**September 10, 2024**

**The Reserves at Grand View Heights – Proj. 22-3262**

**ADDENDUM NO. 3**

**B** APARTMENT BUILDING A & B  
WEST ELEVATION  
1/8"=1'-0"

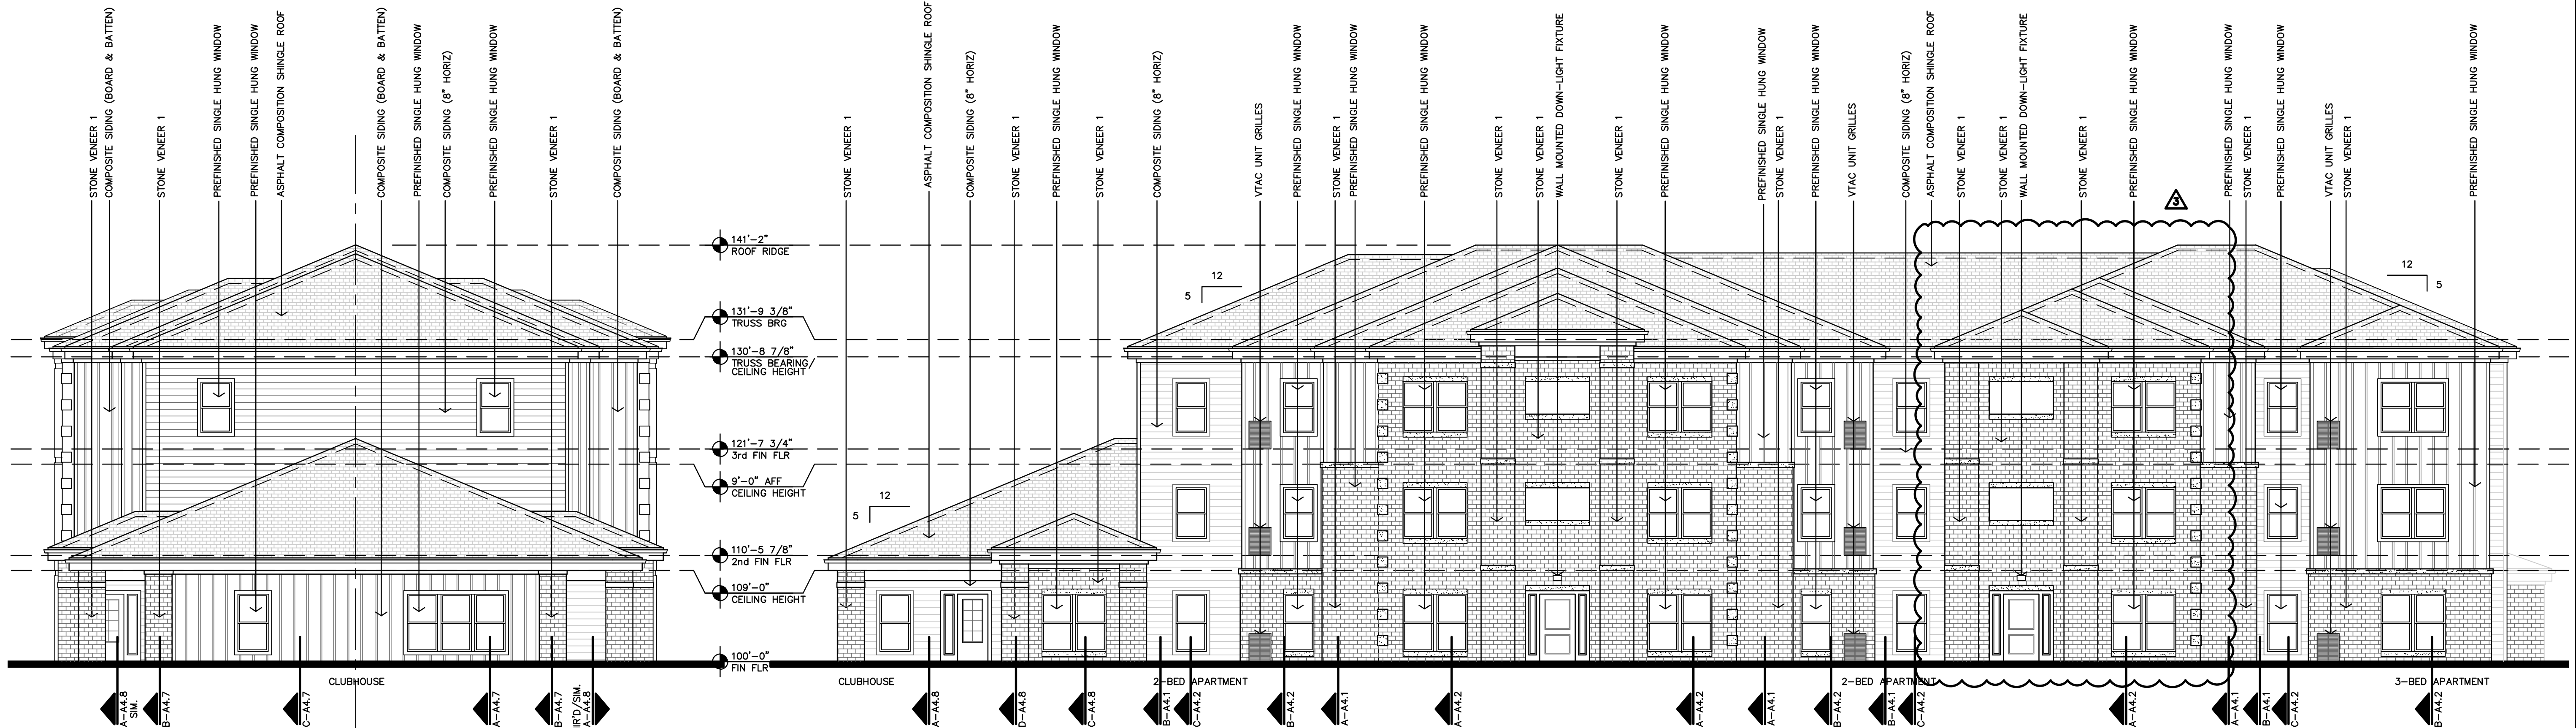
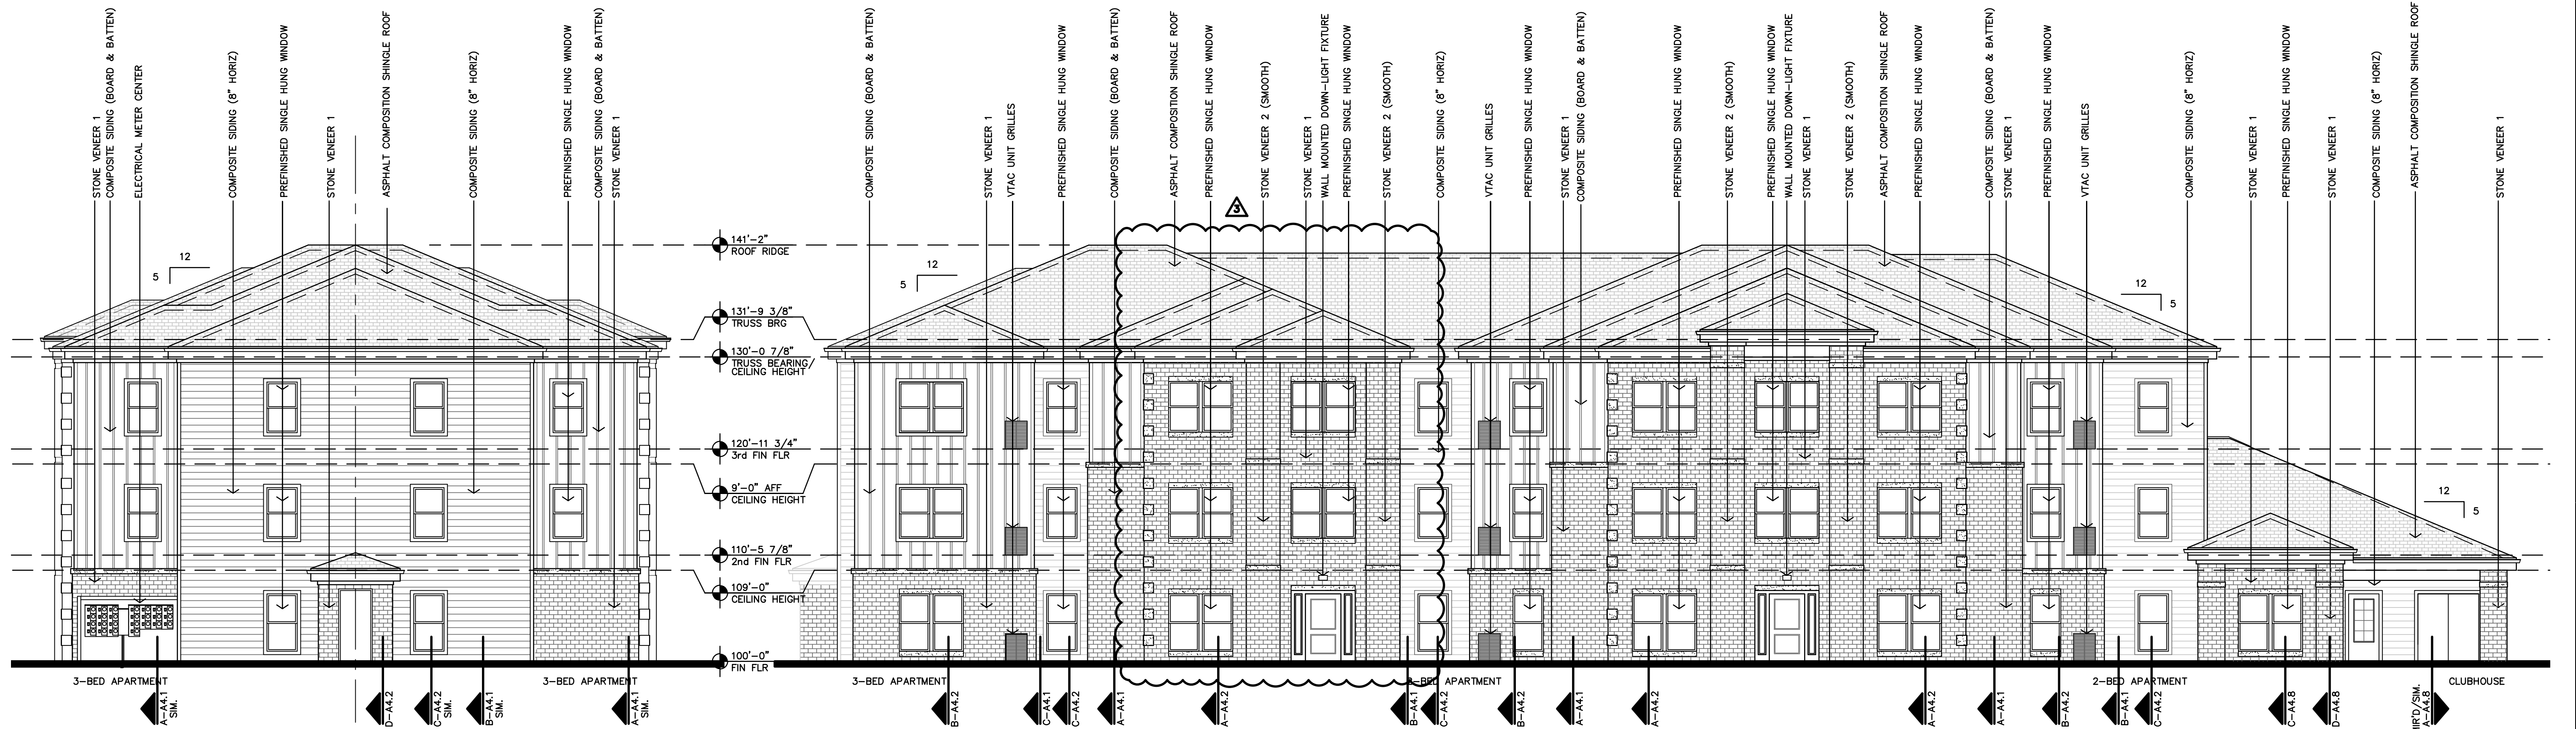
5. Sheet A3.1
  - a. Raised Roof Line above West Entry to Building A has been lowered to match the adjacent roof.
6. Sheet A5.1
  - a. Raised Roof line above West Entry to Building A has been lowered to match the adjacent roof. Continuous Roof vent has been adjusted to fit new roof ridge lines.
